NUCLEAR ENERGY INSTITUTE

PROJECT NUMBER: 689

SUBJECT: Transmittal of the industry's partial responses to the NRC Staff's fifty-two Requests for Additional Information (RAIs) on the S2.1 task report, *Effect of Seismic Wave Incoherence on Foundation and Building Response*

COMMENTS AND RESPONSES TO NRC REQUESTS FOR ADDITIONAL INFORMATION (RAIs)

Figure I-2. Comparison of the Abrahamson and the Luco and Wong coherency models at separation distances of 10 m and 45.75 m (= 150 ft).

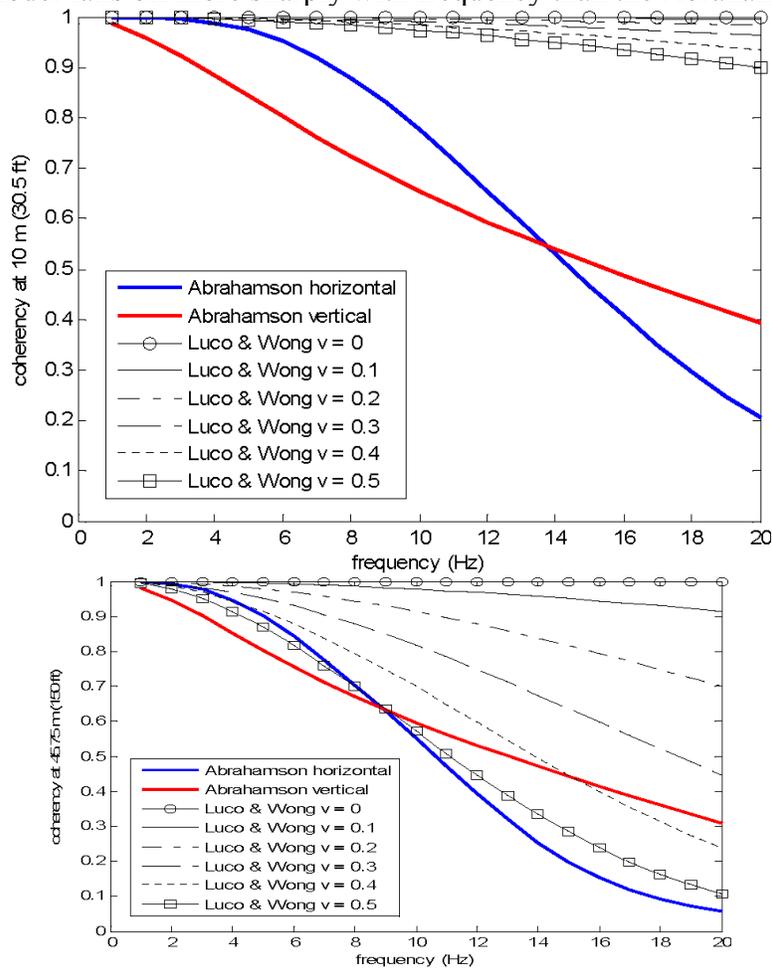
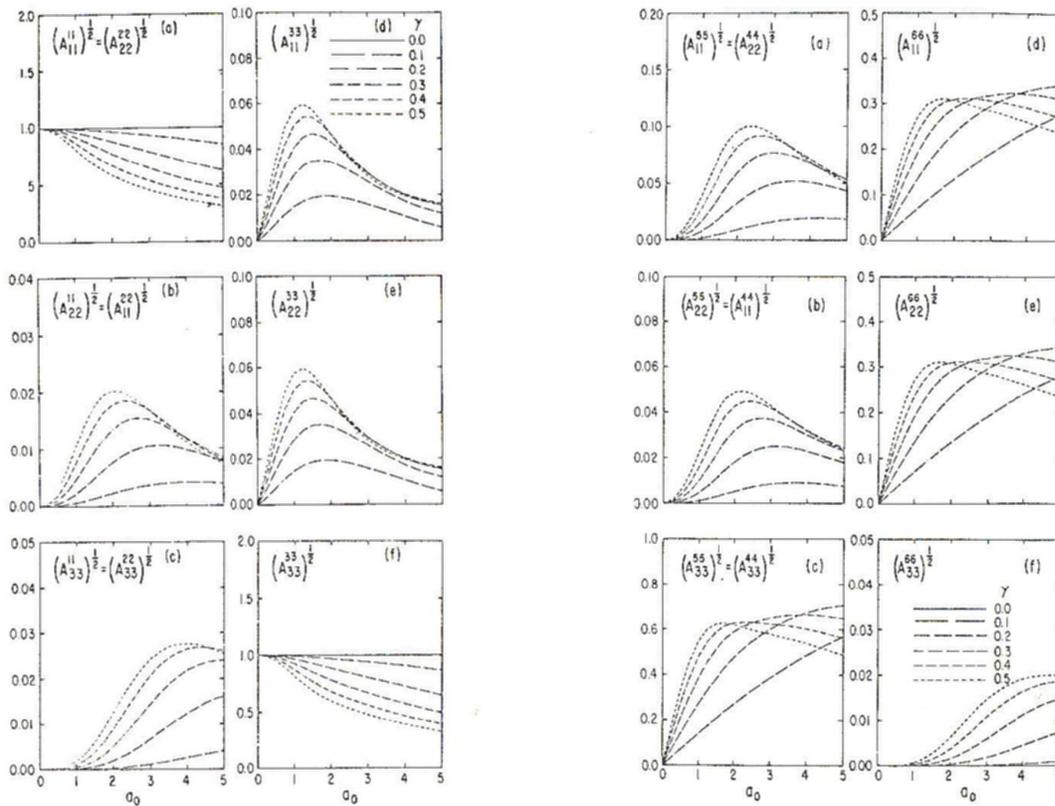
Figure I-3b indicates that rocking caused by the vertical motions (subfigure (c)), and torsion caused by the horizontal motions (subfigures (d) and (e)) can be significant, and increase as ν increases (and coherency decreases, Fig. I-2). It is also noted from Fig. I-3b, subfigures (c), (d) and (e), that as ν increases, the peaks of $\sqrt{A_{33}^{44}}$, $\sqrt{A_{33}^{55}}$, $\sqrt{A_{11}^{66}}$ and $\sqrt{A_{22}^{66}}$ shift towards the lower frequencies. On the other hand, the negligible effect of rocking discussed on p. 6-10 of the EPRI report appears to be counter-intuitive, in that the large reductions in the translational response due to incoherency presented in the report do not result in any rotational effects. Since the Abrahamson coherency model drops more rapidly with frequency and separation distance than the Luco and Wong model (Fig. I-2), this should lead to even higher values for the rotational transfer functions, but it is stated in the report that their effect is negligible. Does the rotational effect become negligible in the report’s study, because, due to the sharp decay of the Abrahamson coherency model, the peak of the rotational transfer functions shifts to such low frequencies where the ground motions do not contain much energy? How do all elements of the $[S_{UoI}]$ matrix of Eq. 3-2 (not only the translational ITFs) behave at different frequencies?

4.52 The ITFs calculated in the present study are presented in Figures 4-13, 4-14, 4-15 and 4-16. These ITFs demonstrate the same shape and trends as Figure 2 of the study by Kim and Stewart (*Kinematic Soil-Structure Interaction from Strong Motion Recordings* by Seunghyun Kim and Jonathan Stewart, Journal of Geotechnical and Geoenvironmental Engineering, April 2003). This Figure 2 depicts the amplitude of the transfer function between free-field motion and the foundation input motion for different foundation shapes based on analytical formulations from Veletsos, Prasad, Luco, Wong, etc. as described in the above reference.
